Prescott & Springdale Schematic with Capture CIS and Function field

REV: X00-G

Compal Electronics, Inc.			
Title			
Cover Sheet			
Size	Document Number		Rev
	LA-1711		X00-G
Date:	Tuesday, March 18, 2003	Sheet	1 of 54

Version Change List (P. I. R. List) Page 1/3

Title	+1.5VRUNP & +VTT_GMCHP
-------	-----------------------------------

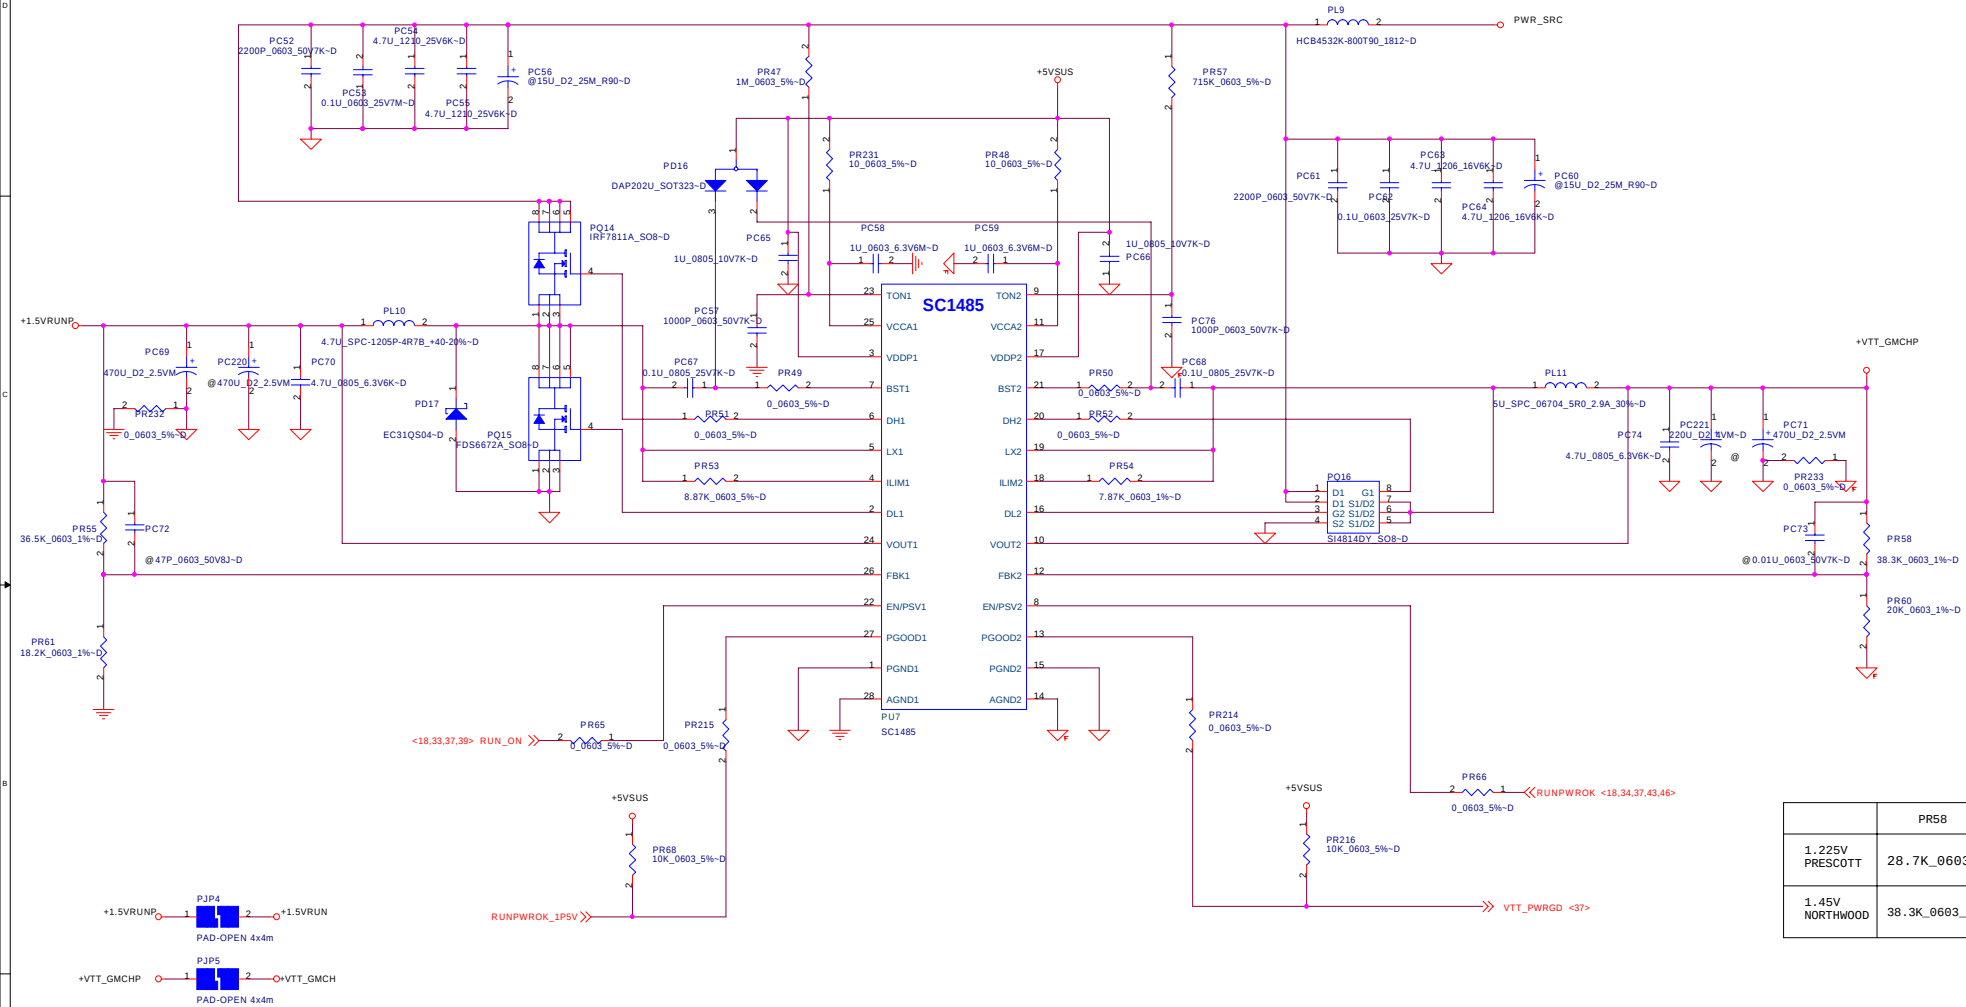
5	44,45	+1.5VRUNP/ +VTT_GMCHP 1.25V/2.5V	3/07/2003	DELL	Intersil ISL6225B IC issue. So change controller IC.	Change PU7 to SC1485 and PU8 to SC1486.	X00-E
6	45	1.25V/2.5V	3/12/2003	DELL	Dell X00 Board issue item47: Intle in the DG 1.21 update have changed the DDR voltage to 2.6V and Term voltage to 1.3.	Change PR72 to 42.2K	X00-F

Compal Electronics, Inc.			
File		Subwoofer	
Size	Document Number	Rev	
LA-1711		X00-G	
Date:	Tuesday, March 18, 2003	Sheet	50 of 54

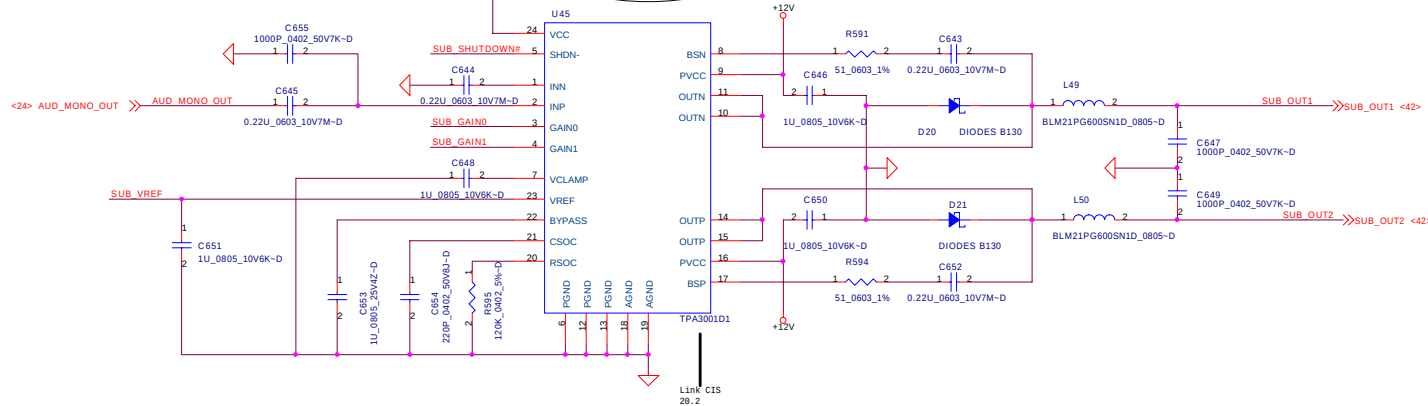
40	29	LAN TRANSFOMER	3/14/2003	DELL	Dell Schematic issue item45,46 the BJT werent driving the LED enough	1.Change Q3 from DTC144KA_SOT23 to 2N7002 2.LED_WLAN5_RADIOSTATE, LED_WLAN24_RADIOSTATE, and WLAN_LED_ACTIVITY. Add 10K_0402_5% pulldown resistor(R600~R602) [BOM need change]	X00-G
41	50	Subwoofer	3/14/2003	DELL	Dell Schematic issue item48 Move D18 and D19 to page 42, and update all component Symbols	Move D18 and D19 to page 42, and update all component Symbols , move C655 from current location to in between C645 and U45 pin 2 and change value to 1000P_0402_50V7K	X00-G
42	6	Clock Generator	3/14/2003	DELL	Dell Schematic issue item30 Springdale DG P65 recommend a 10 Ohm resistor from CK_VDD_MAIN to Pin VDD_48 (pin34) of Ck409	Reserved power source option: populate R599. depopulate R599 [BOM need change]	X00-G
Delete by Dell's update issue_0314 ;X00-H							
43	11	Springdale-DDR Interface	3/18/2003	Compal	Intel recommend is 31.12K,the value isn't popularize. Follow Dell's DT team use 30.9K	Change R101,106,369,373 from 31.12K_0603_1% to 30.9K_0603_1% ;[BOM need change]	X00-H
